Product Change Notification

1. ECR #: 211640
Notification #: 622

- QFSS - .635mm DOUBLE ROW SHIELDED TERMINAL STRIP
- QFS - QFS .635mm STRIPS

4. Part #'s Affected

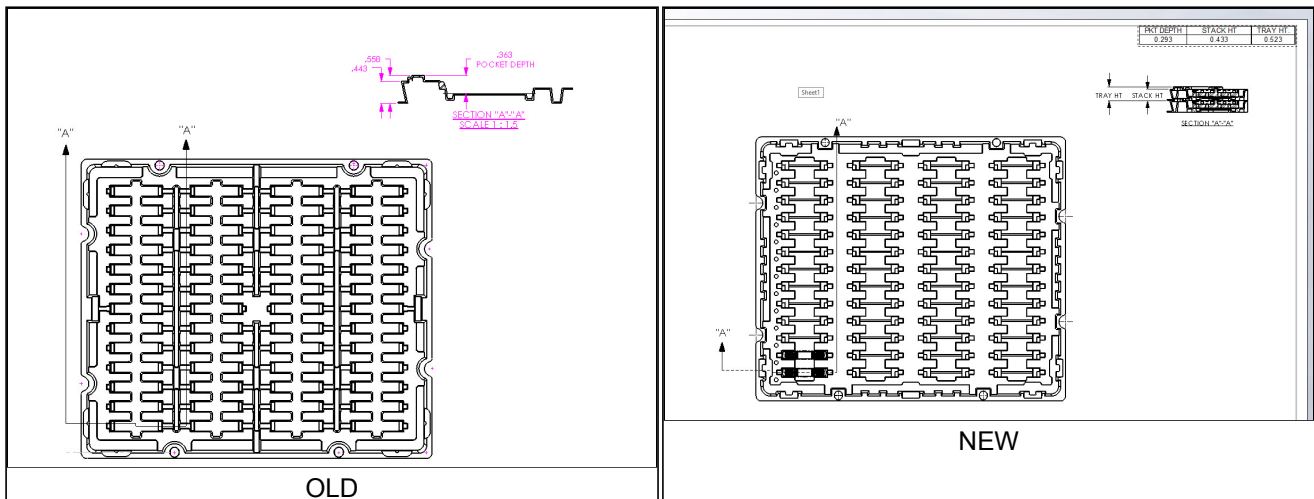
Update tray to the current design standard which means changes to pocket depth, tray height, and stack height.

Pocket depth change from 0.363" to 0.293" ; tray height change from 0.558" to 0.533" ; stack height change from 0.443" to 0.433"

The current design standard and resulting changes allow the tray to hold the part more securely and with greater stability.

- Fit - Pocket depth , tray & stack height
